Preliminary Information

PIT5926 Rattle Noise from Under Vehicle

Picture of Blue Heat Shield Retaining Clip Installed

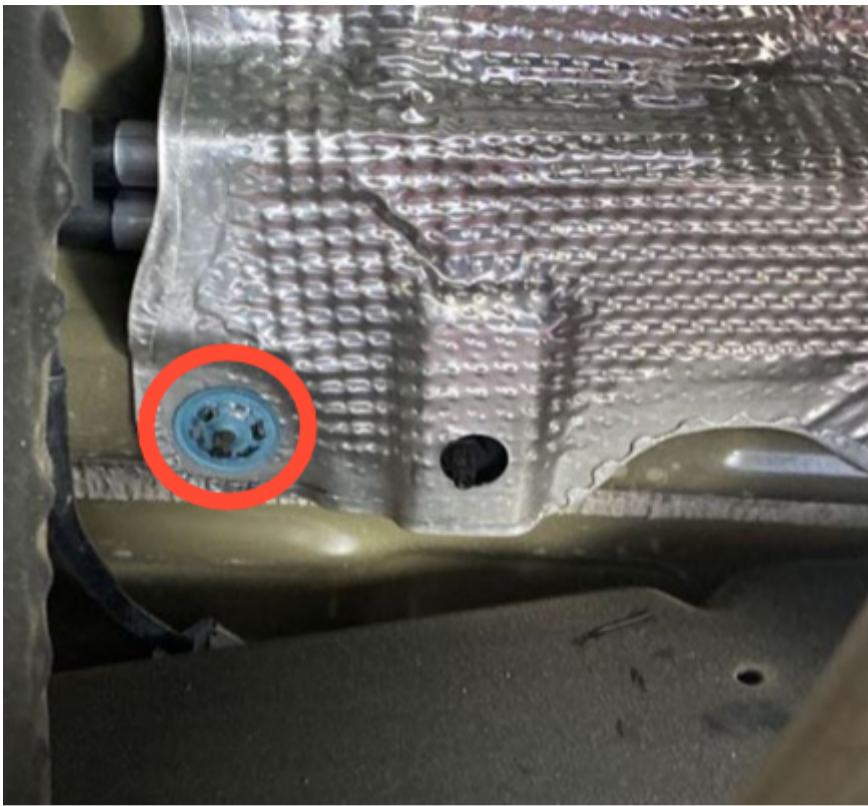
Involved Region or Country	North America
Condition	Some customers may comment on a rattle noise from under the vehicle while driving.
Cause	The retainer clips that hold the Exhaust Underbody Heat Shield may have become loose or missing, shown below.

Install updated retainer clip P/N 11602886 for Silverado 1500 / Sierra 1500 and P/N 11603508 for SUV and tighten by hand until heat shield is secured into position.
